**STATE OF INDIANA  
INDIANA UTILITY REGULATORY COMMISSION**

**CAUSE NO. 44446**

**Direct Testimony of  
Jeremy I. Fisher, PhD**

**On Behalf of  
Sierra Club, Citizens Action Coalition, and Valley Watch.**

**Figure 5.**  
Capacity from Vectren units and market-based capacity purchases (MW),  
Culley 3 replaced with 202 MW CT scenario (UCAP).

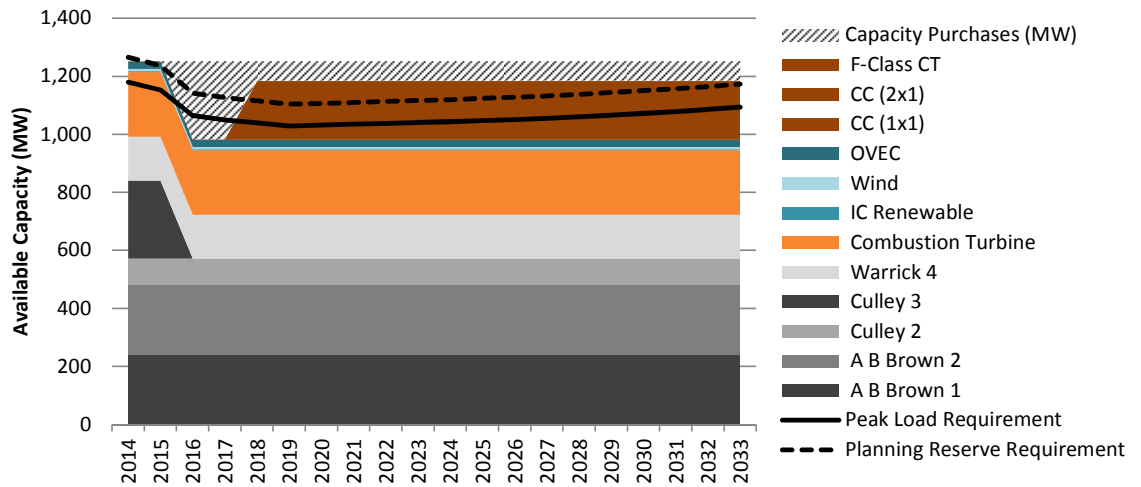
20 For example, in the scenario where Culley 3 is replaced with a 202 MW CT that  
21 comes online in 2018, the analysis assumes that Vectren has to acquire 269 MW  
22 of market capacity in 2016 & 2017 to fill the gap left by Culley 3; the analysis  
23 also assumes an acquisition of 67 MW of market capacity (the difference between  
24 the 269MW Culley 3 unit and the 202 MW CT replacement) from 2018-2033  
25 despite the fact that this market capacity is not necessary to meet the Company’s  
26 reserve requirements (see Figure 5, below).<sup>38</sup>

**Figure 6.**  
Capacity from Vectren units and market-based capacity purchases (MW).  
Brown 1 & 2 replaced with 620 MW CC (UCAP).

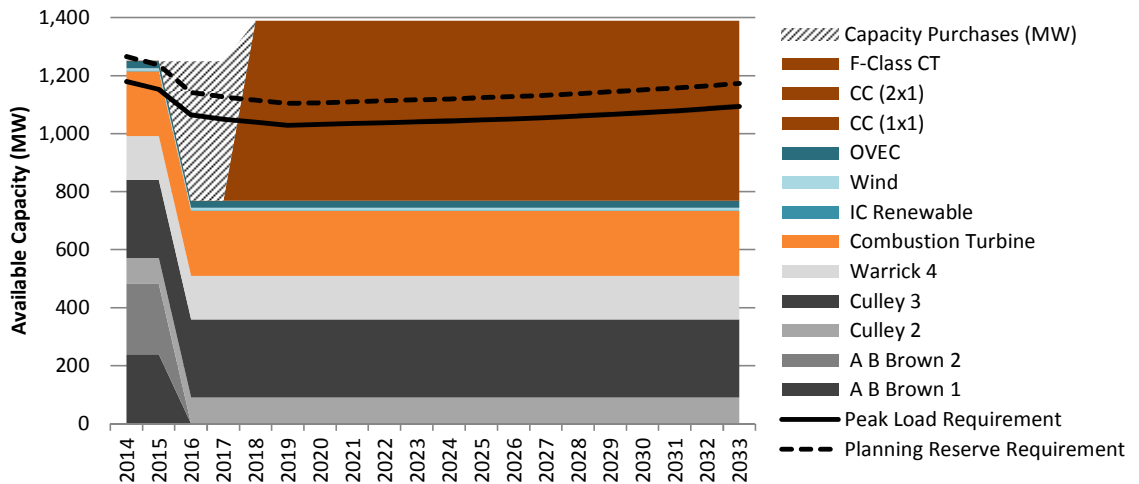
5 However, when a replacement unit larger than the retiring unit is brought online,  
6 the Company does not assume equivalent capacity market sales for excess  
7 capacity. Instead, Vectren assumes no monetary benefit for maintaining excess  
8 capacity, despite the reserve margin being well in excess of requirements, as  
9 shown in Figure 6 below.

9 **Confidential Figure 9.**

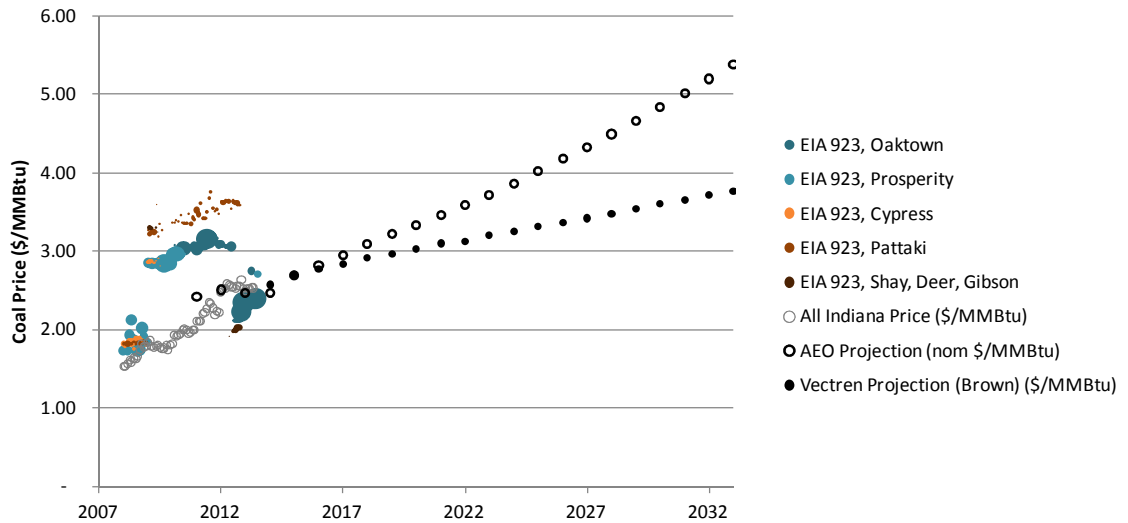
8 This trajectory is shown in Confidential Figure 9, below.

**Figure 11.**  
Net revenues at Brown and Culley, 2010-2013, inclusive.

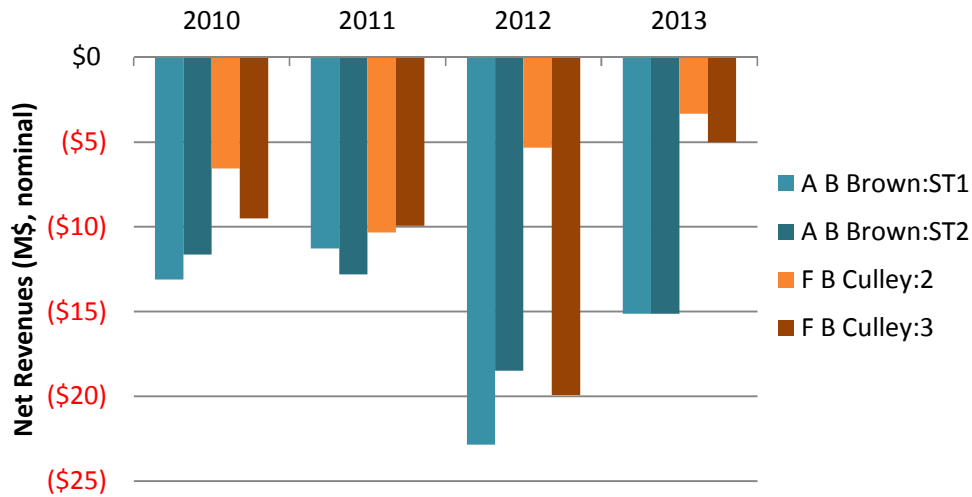
18 My estimate of the Company’s net revenues at these units is shown in Figure 11,  
 19 below. This figure shows that across the last four years, if Brown and Culley had  
 20 operated as merchant plants, they would have taken significant losses – from \$5 to  
 21 \$20 million per year, every year – or a total of \$190 million.

3           For each year, I multiplied hourly LMP by hourly dispatch to arrive at a gross  
4           revenue, and then deducted fuel and variable and fixed O&M costs to arrive at a  
5           net revenue. These are the net costs shown in Figure 11, above. Importantly, these  
6           net costs do not include annual capital expenditures made by the Company for  
7           environmental or long-term maintenance at the units. Incorporating those costs as  
8           expenses would just increase the losses of these units.

**Figure 13.**  
Capacity from Vectren units and market-based capacity purchases (MW),  
Brown 1 & 2 replaced with a 396 MW CCGT (duct fired, UCAP).

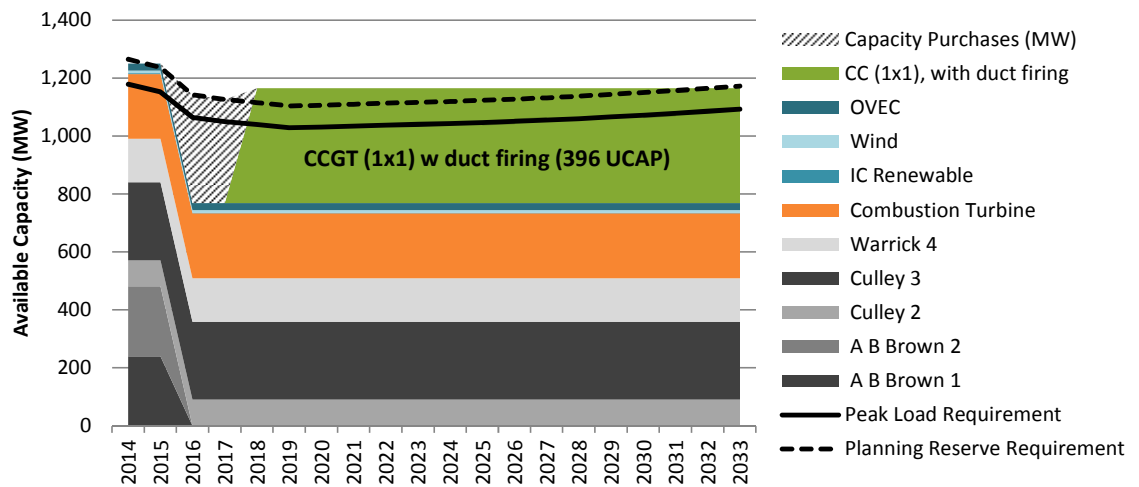
13 **A** No. The Company’s 1x1 CCGT replacement was modeled without the benefit of  
14 duct-fired burners, although this option was laid out by B&Mc in their 2013  
15 technology assessment.<sup>61</sup> If the Company retired Brown 1 & 2, it would lose 481  
16 MW of unforced capacity (UCAP), rendering it short by 373 MW in 2016  
17 (relative to planning reserve requirements). The 1x1 CCGT examined by B&Mc  
18 has an installed capacity (ICAP) of 317.5 MW, and a duct-fired option of 91 MW.  
19 At a forced outage rate of 3%, this would result in 396 MW of UCAP. With the  
20 Company’s falling load requirements, I anticipate that this replacement would  
21 meet the Company’s requirements through 2032.

9 **A** No. I did not have access to the Company's model, and did not assess the  
10 economics of this option. I believe that, because of the lower capital burden to  
11 build this 1x1 CCGT, this analysis would have likely resulted in a lower cost  
12 resource plan.
